The Sizewell C Project

2.8 Two Village Bypass Plans For Approval

July 2021

Two Village Bypass Plans For Approval – Revisions Schedule

TWO VILLAGE BYPASS - LONGSECTION 01
SCALE: H 1:2500, V 1:500, DATUM: 0.000

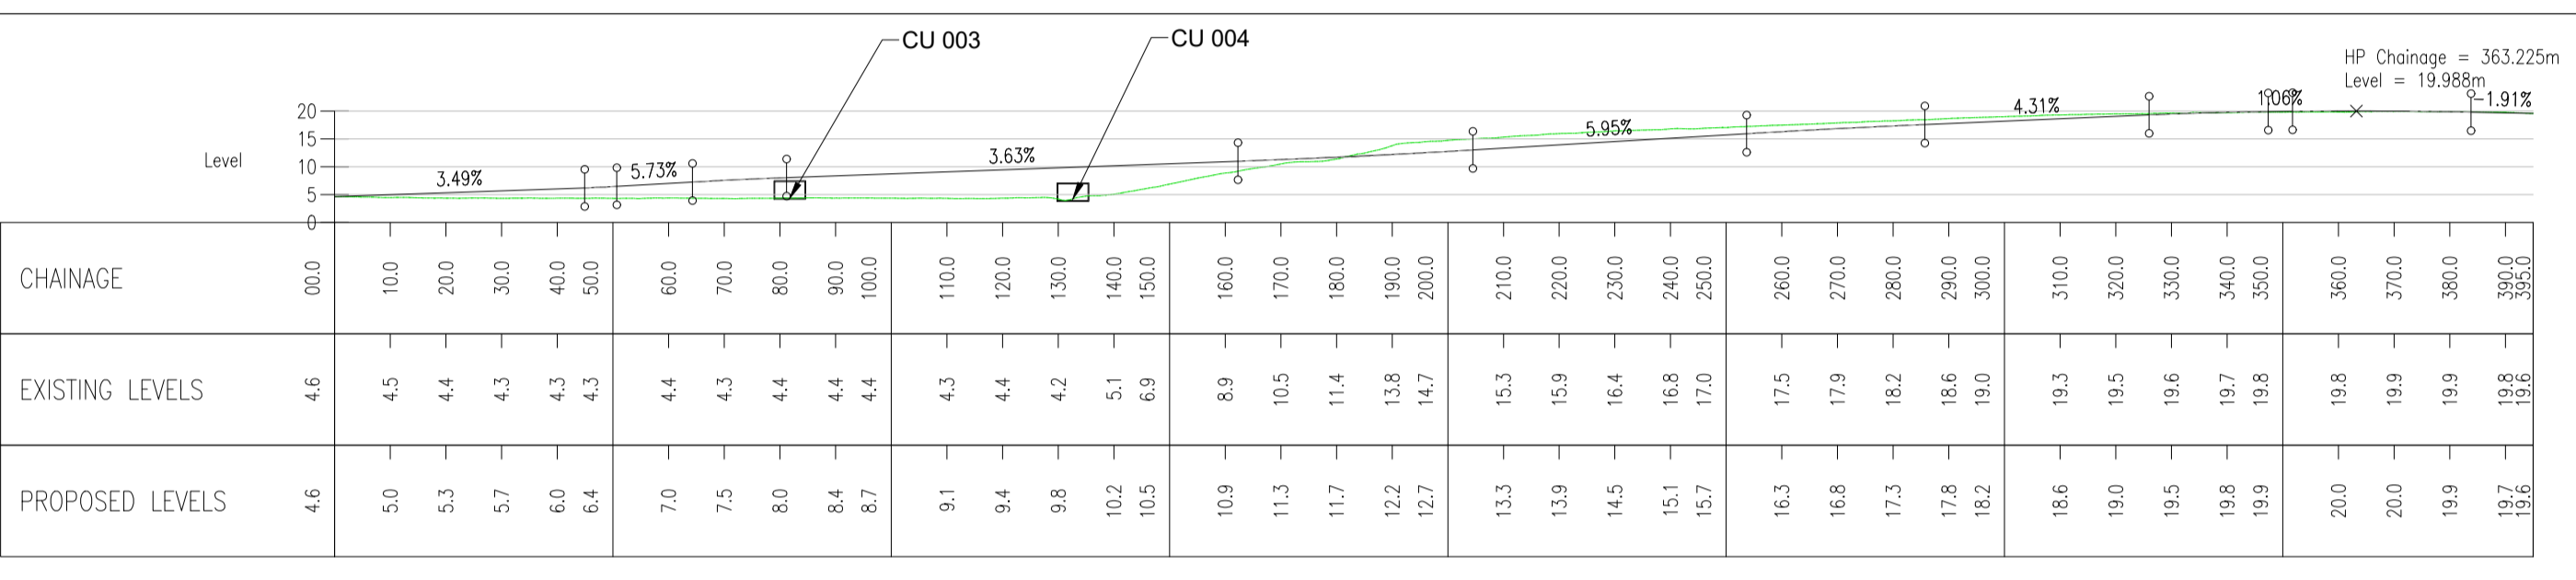
Drawing Number	Revision	Drawing Title	Amendments
SZC-SZ0204-XX-000-DRW-100038	02	Two Village Bypass Proposed General Arrangement And Profiles - Sheet 1 of 2	Increased Order Limits due to design changes, additional indicative western construction compound and changes to key.
SZC-SZ0204-XX-000-DRW-100522	02	Two Village Bypass Proposed General Arrangement And Profiles - Sheet 2 of 2	Increased Order Limits due to design changes, additional indicative western construction compound and changes to key.
SZC-SZ0204-XX-000-DRW-100039	02	Two Village Bypass A12/A1094 Eastern Roundabout Proposed General Arrangement	Change to key ('Indicative Construction Compound Areas')
SZC-SZ0204-XX-000-DRW-100040	02	Two Village Bypass A12 Western Roundabout Proposed General Arrangement	Changes to key
SZC-SZ0204-XX-000-DRW-100450	01	Two Village Bypass A12/A1094 Eastern Roundabout Proposed Profiles	No updates made.
SZC-SZ0204-XX-000-DRW-100451	01	Two Village Bypass A12 Western Roundabout Proposed Profiles	No updates made.

DRAWING TITLE:
 TWO VILLAGE BYPASS
 PROPOSED STAGGERED JUNCTION
 PLAN AND PROFILES

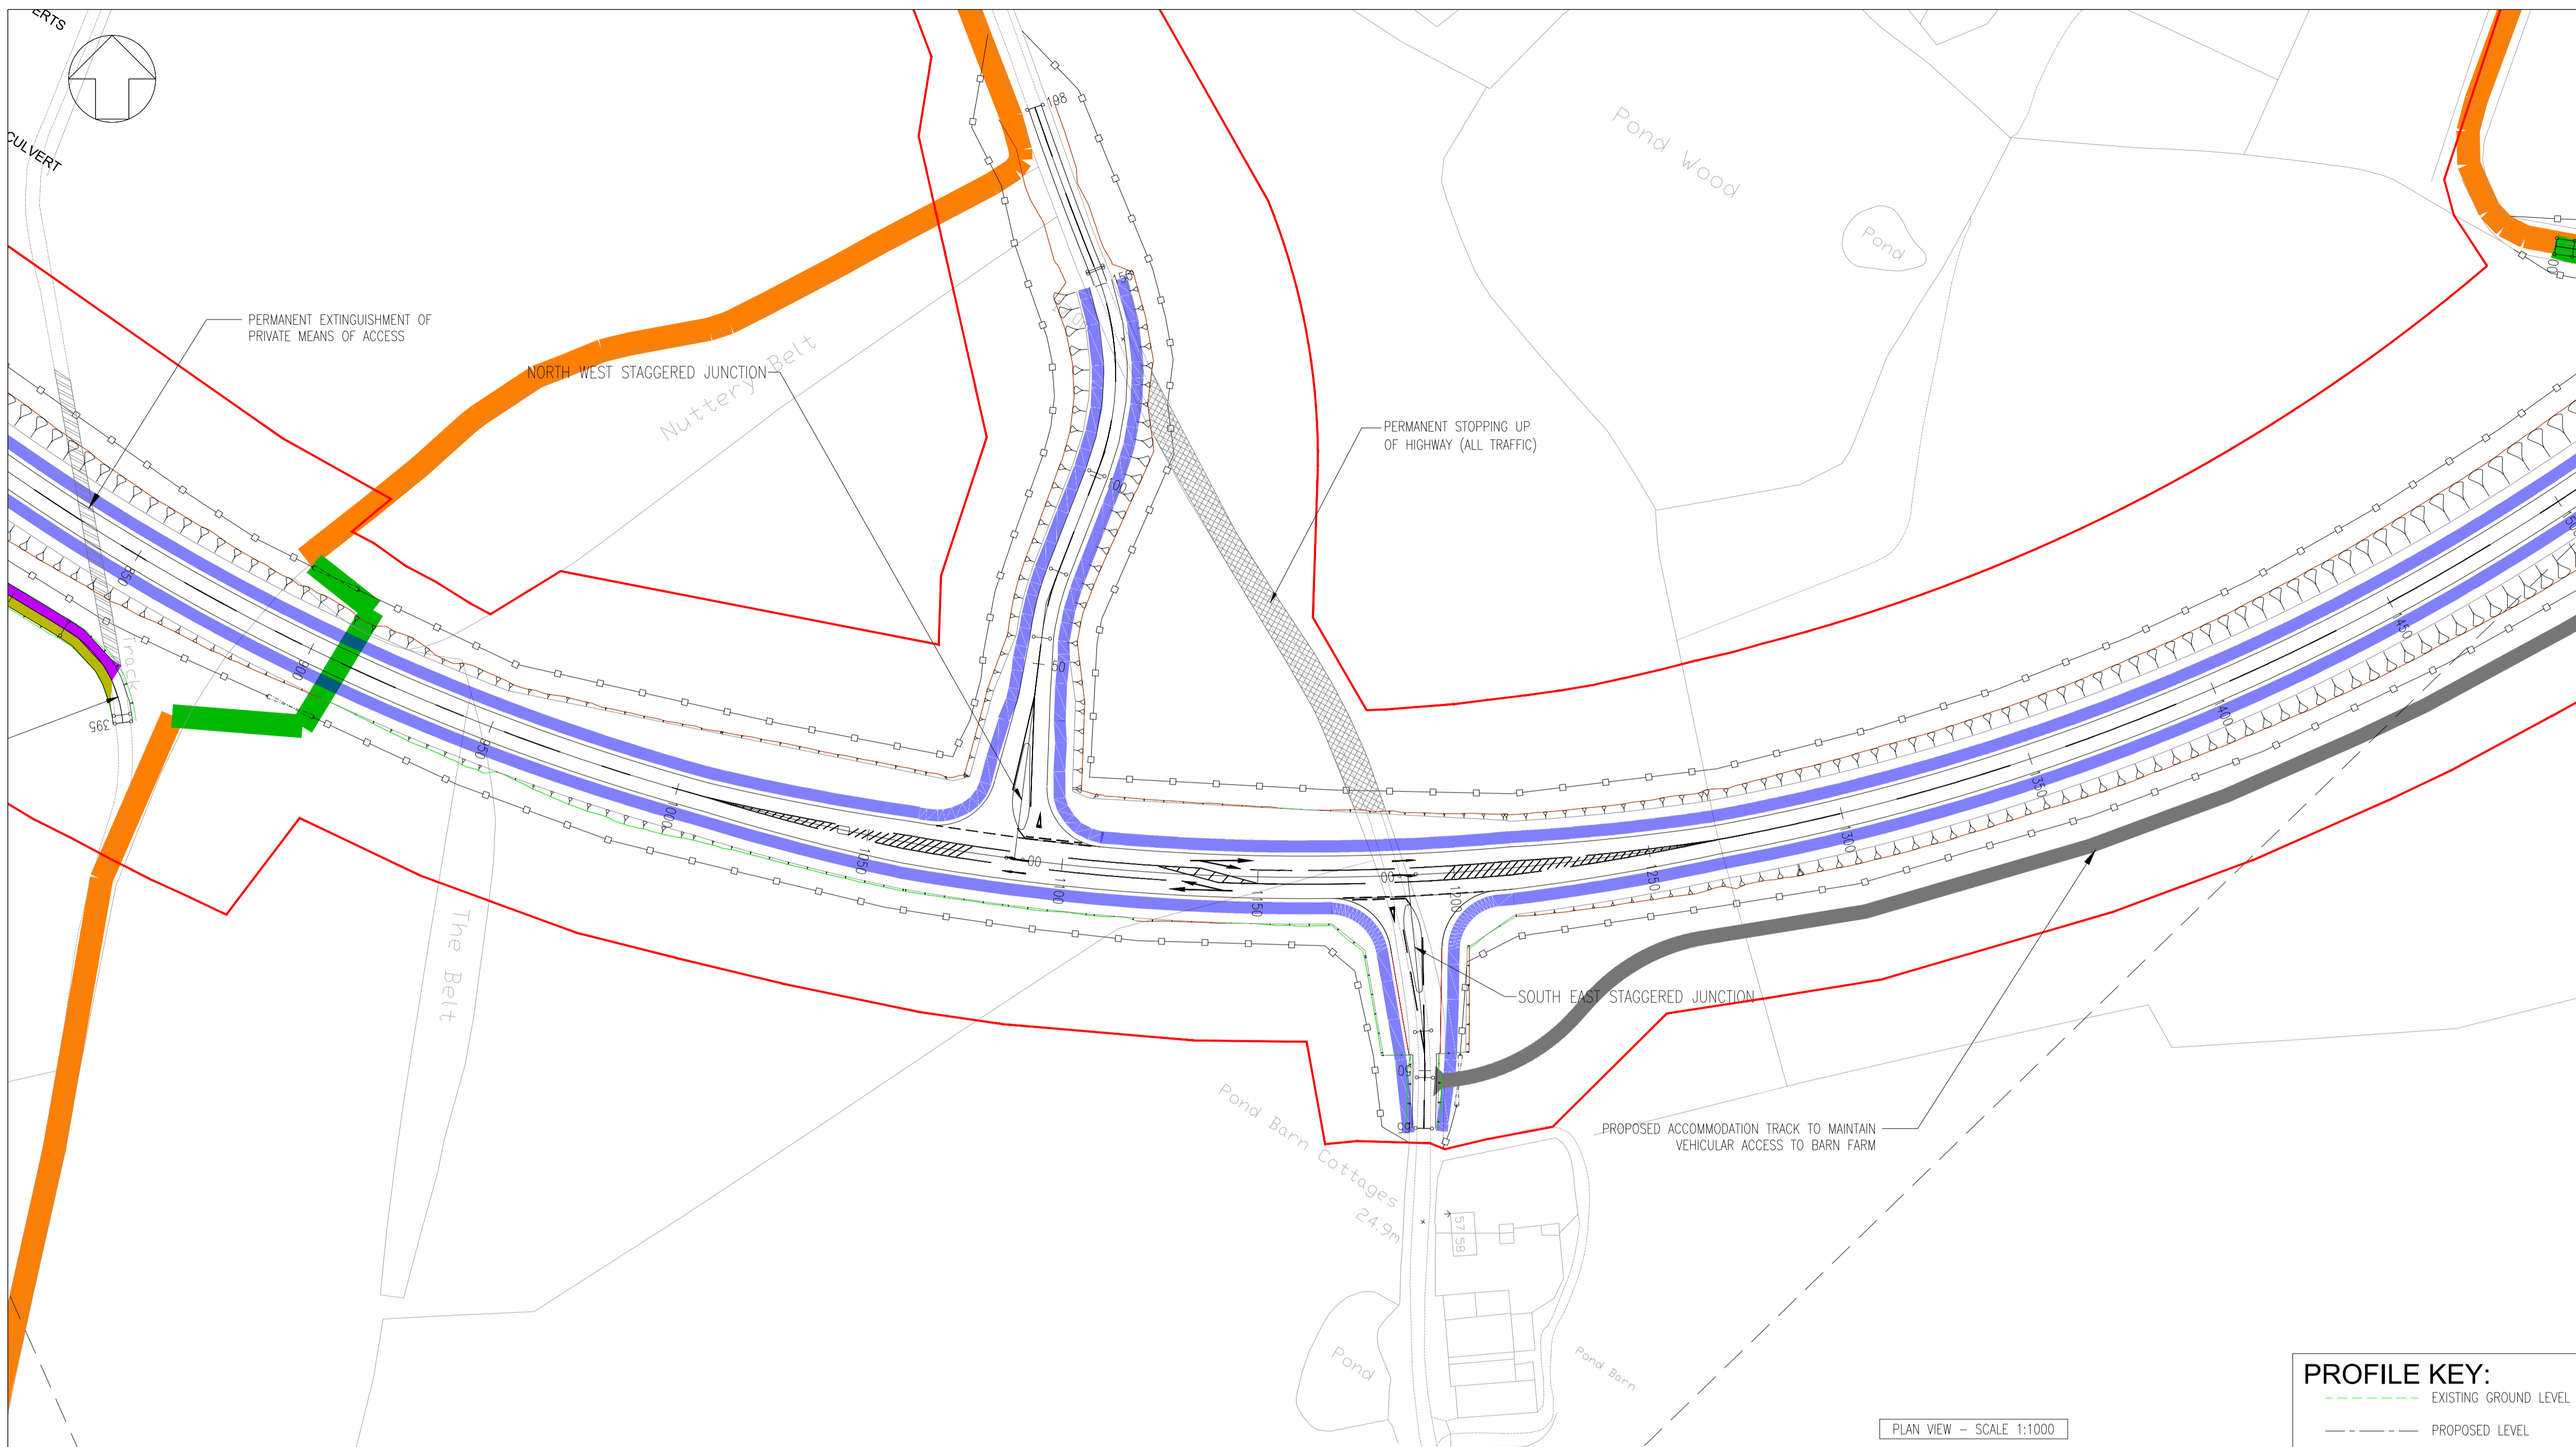
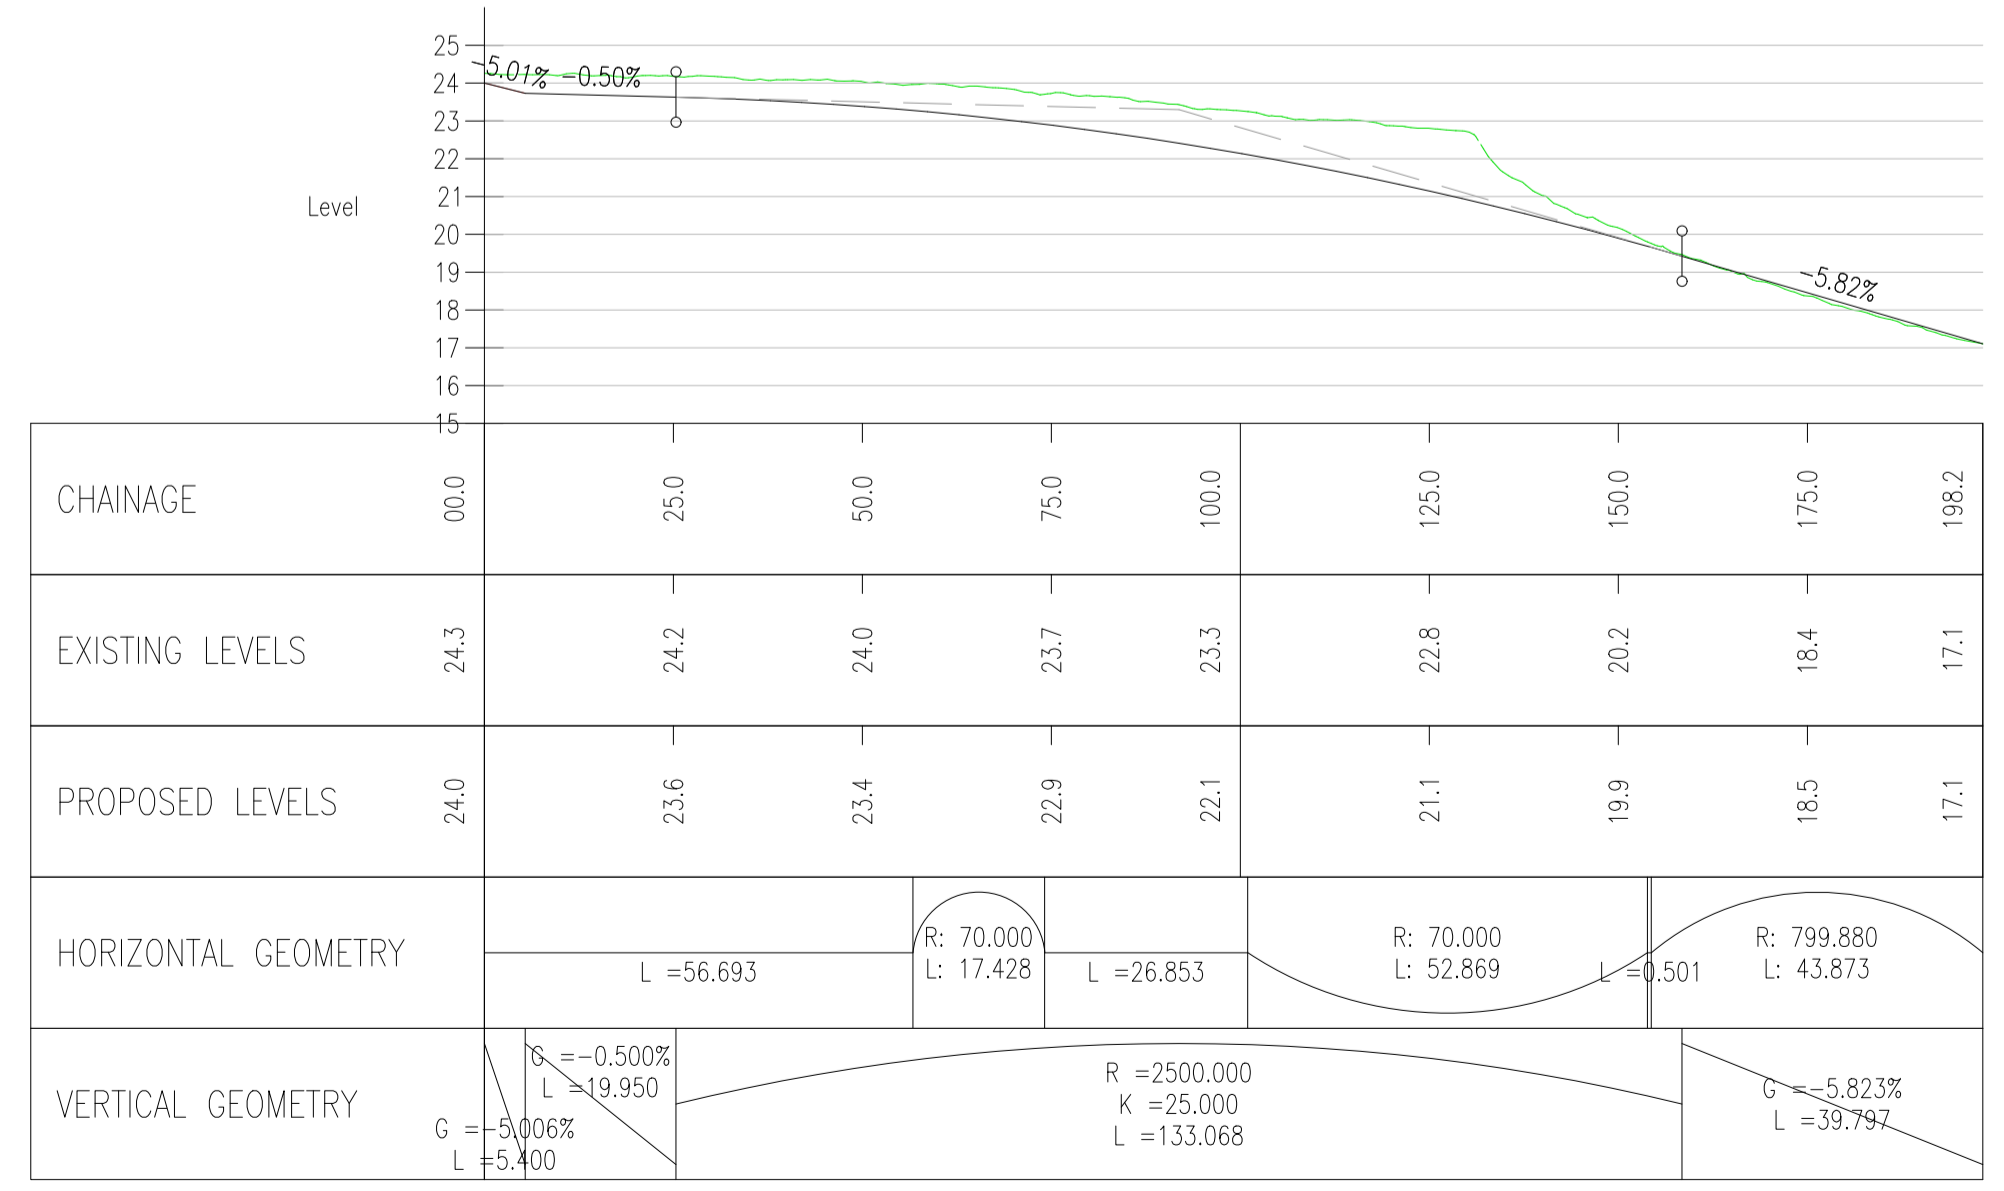
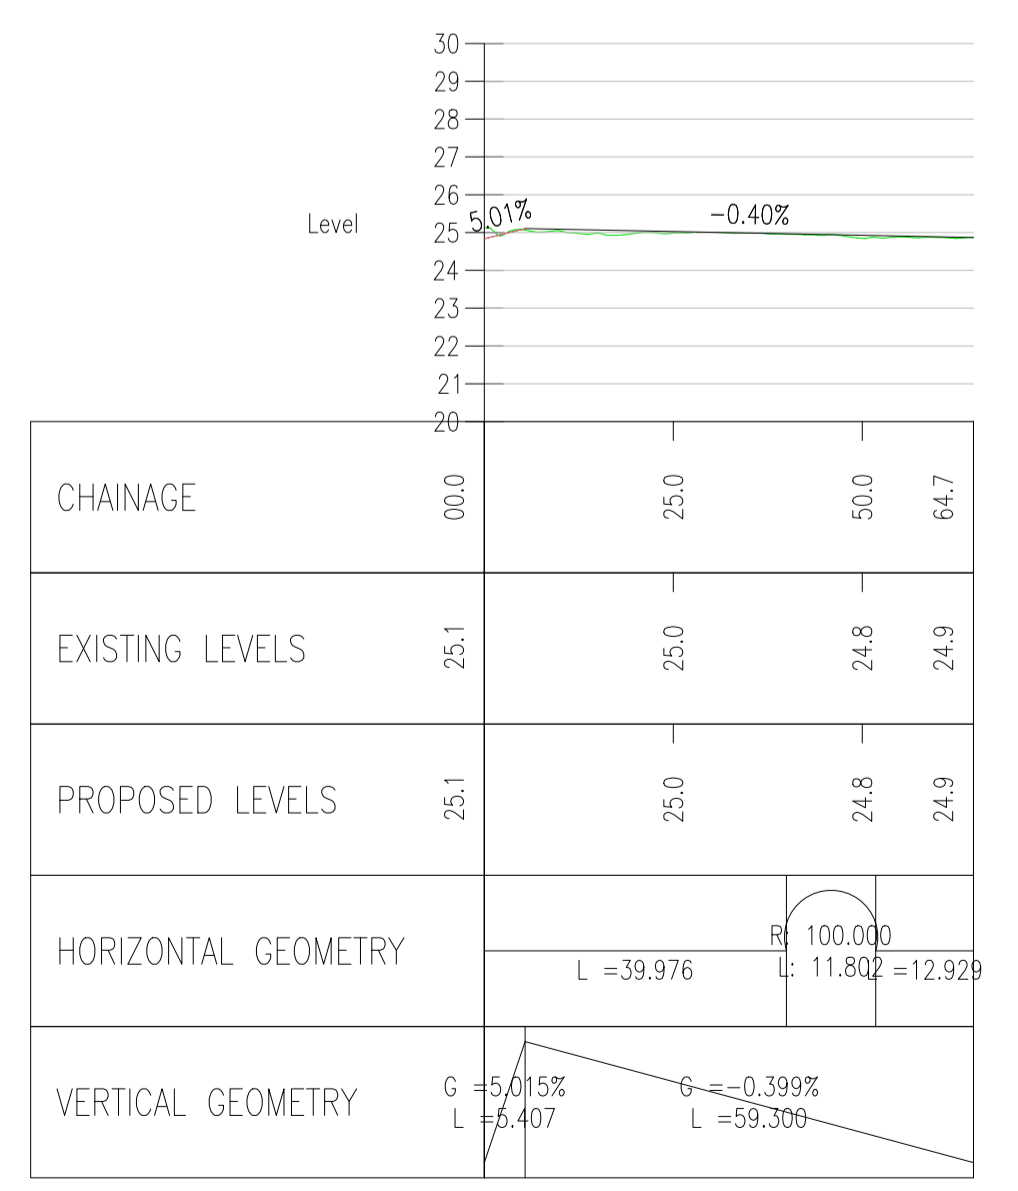
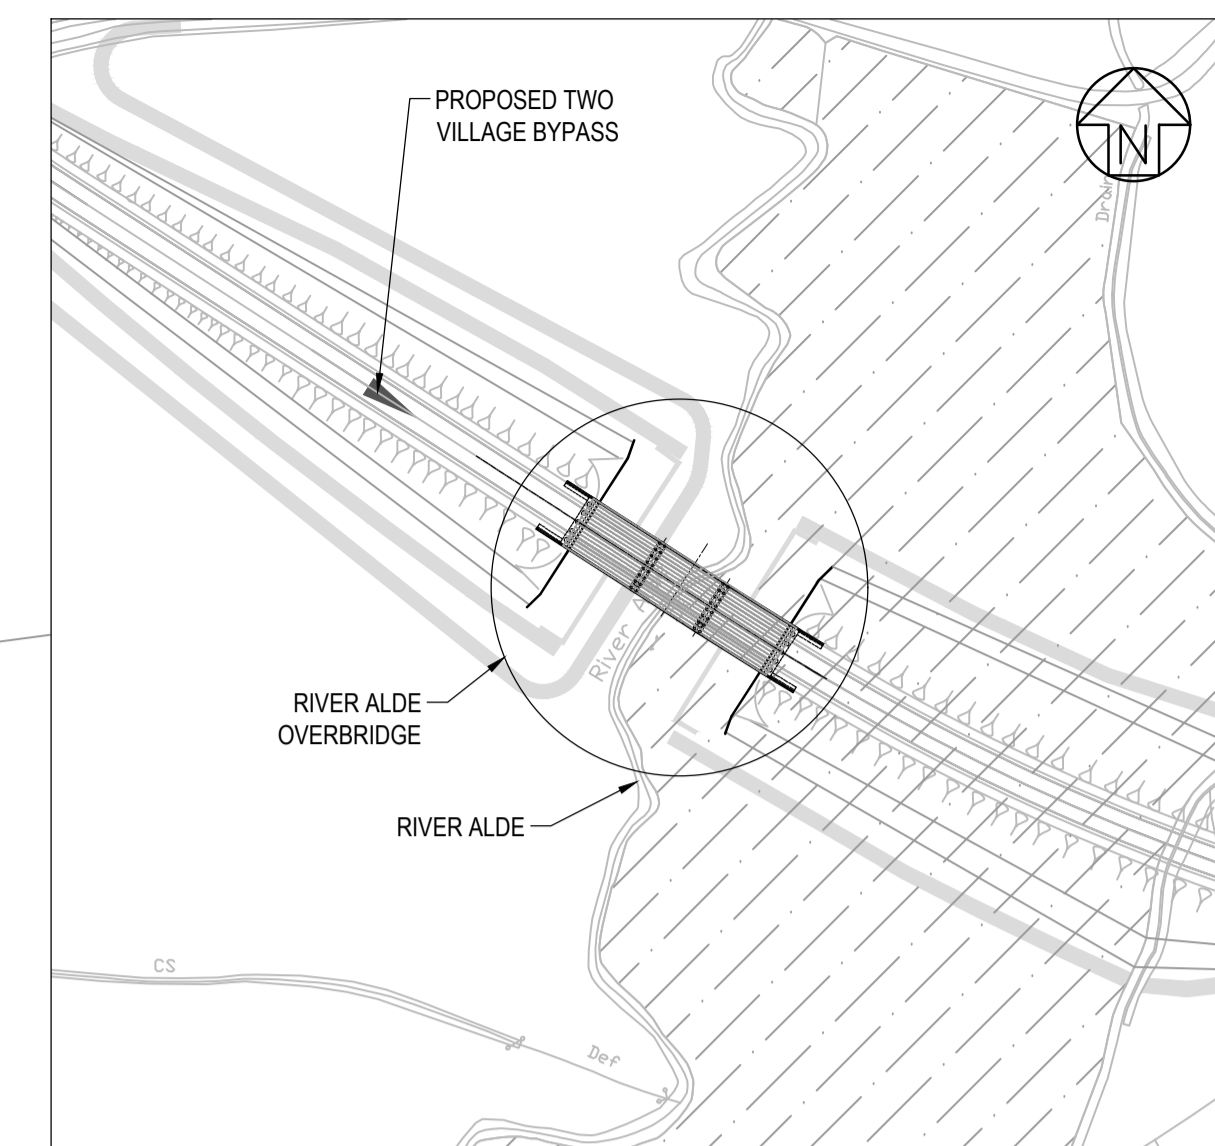
SZC-SZ0204-XX-000-DRW-100452	02	Two Village Bypass Proposed Staggered Junction Plan And Profiles	Increased Order Limits due to design changes and changes to key.
SZC-SZ0204-XX-000-DRW-100293	01	River Alde Overbridge Proposed General Arrangement And Elevation	No updates made.
SZC-SZ0204-XX-000-DRW-100290	01	Foxburrow Wood Footbridge Proposed General Arrangement And Elevation	No updates made.
SZC-SZ0701-XX-000-DRW-100166	02	Two Village Bypass Proposed Landscape Masterplan And Finished Levels - Sheet 1 of 2	Increased order limits due to design changes, addition of indicative floodplain grassland mitigation area and changes to key.
SZC-SZ0701-XX-000-DRW-100167	02	Two Village Bypass Proposed Landscape Masterplan And Finished Levels - Sheet 2 of 2	Increased order limits due to design changes and changes to key.
SZC-SZ0701-XX-000-DRW-100168	02	Two Village Bypass Site Clearance Plan - Sheet 1 of 2	Increased order limits due to design changes and changes to key.
